Subject: Response to NDEP September 18, 2008 Comments
Data Validation Summary Report (DVSR), Phase B Source Area Investigation
Soil Gas Survey, Tronox LLC Facility, Henderson, Nevada
Dated August 25, 2008

Tronox Response to Comments

September 18, 2008 NDEP Letter Regarding Data Validation Summary Report (DVSR), Phase B Source Area Investigation Soil Gas Survey, Tronox LLC Facility, Henderson, Nevada (August 2008)

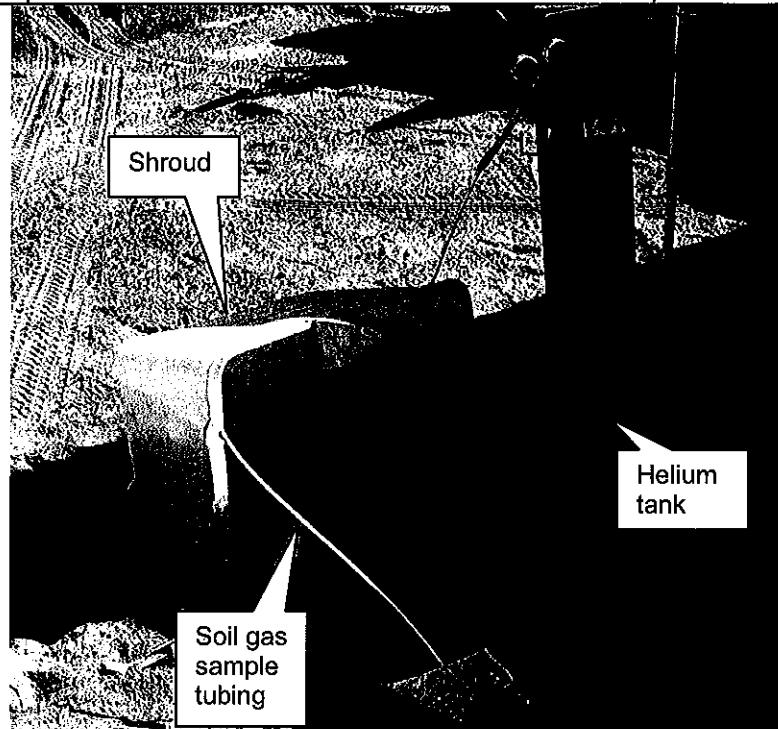
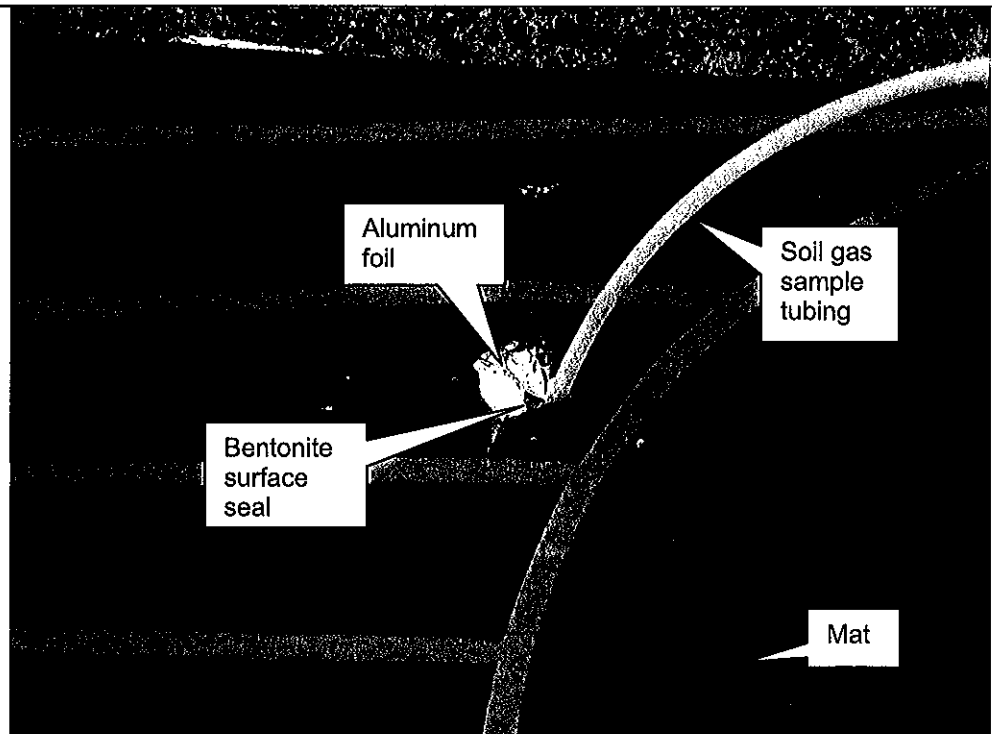
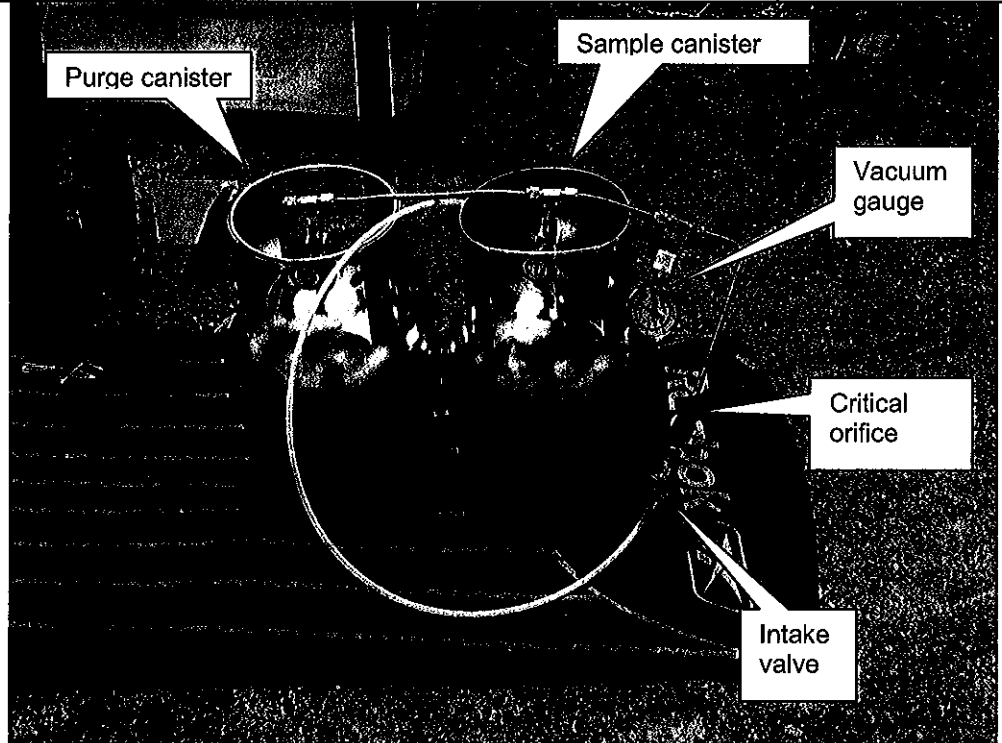
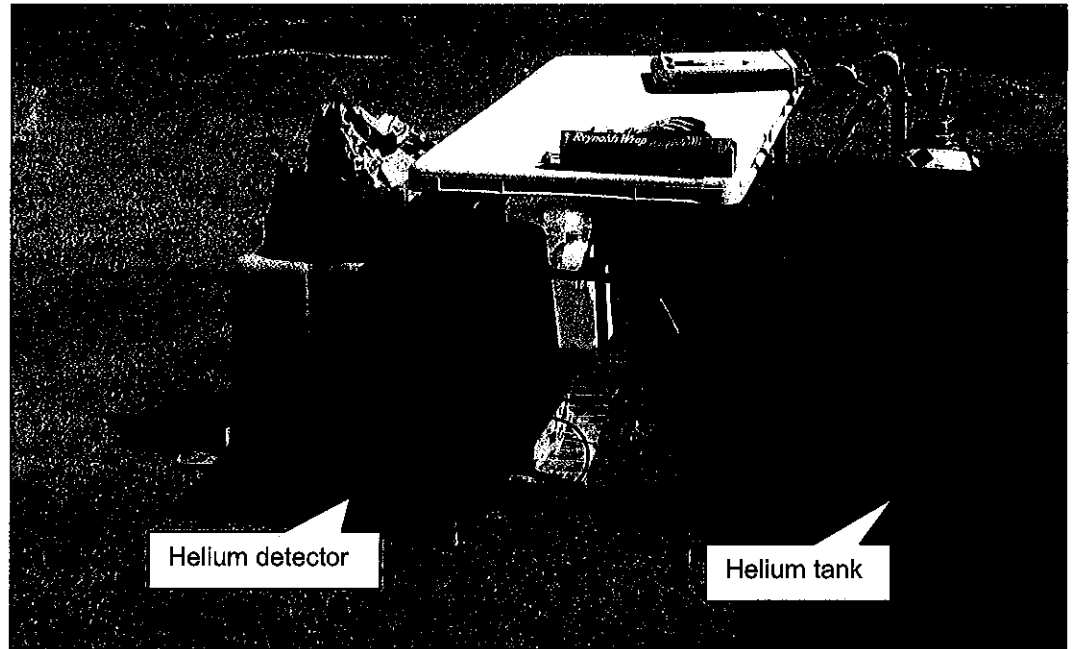
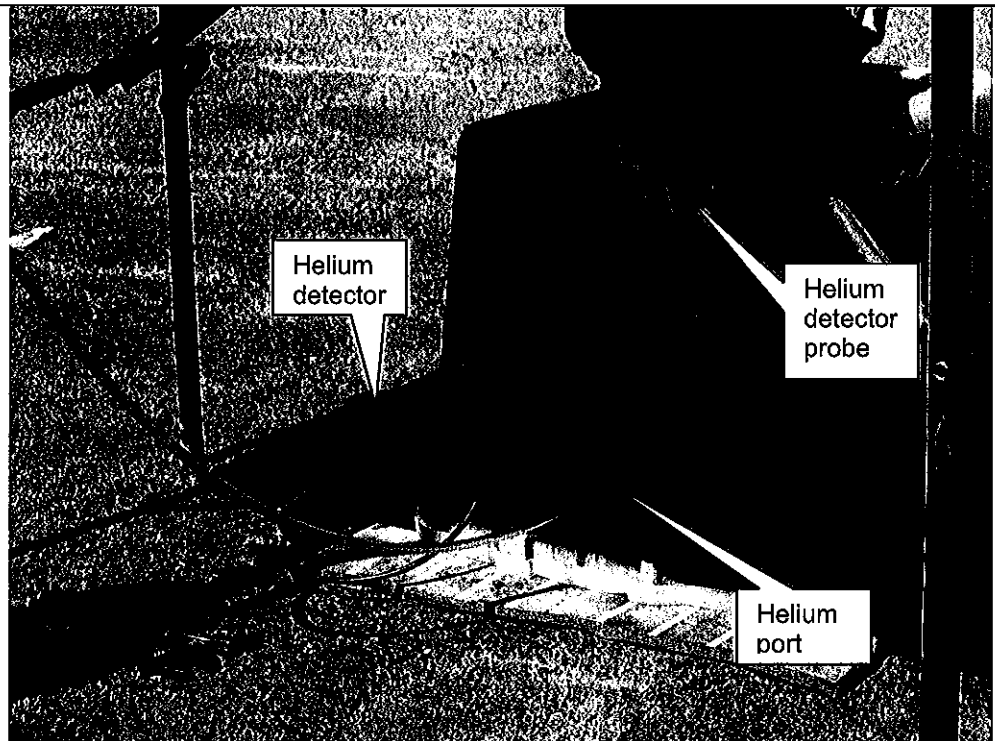
- 1 **Helium Analysis:** Review of the laboratory reports from Columbia Analytical Services shows that helium analysis, using a modified method 3C, was performed on the Summa canister samples. It is unclear why helium analysis was required and why the soil gas samples would be exposed to helium. The DVSR should provide details on why helium analysis was performed along with a discussion of what impact helium detection in a sample has on the TO-15 results. For example, does helium indicate a soil gas sample was influenced from a purge gas? If helium detection in a sample does impact the VOC results the DVSR should also provide a validation of the helium analysis along with a discussion of the impact of helium results on the VOC data.

For the Phase B soil gas survey, the above-ground portion of the sample system (i.e., summa canisters, flow-controller, vacuum gauge, valves and tubing connections) was placed under a shroud (plastic box). Helium gas (provided by a compressed gas vendor) filled the shroud, creating an atmosphere surrounding the sampling system with between 5% to 55% helium. A hand-held helium meter was used to monitor the atmosphere within the shroud to ensure that the helium concentration was maintained as each sample was collected (see the attached **photos numbered 1 through 6**).
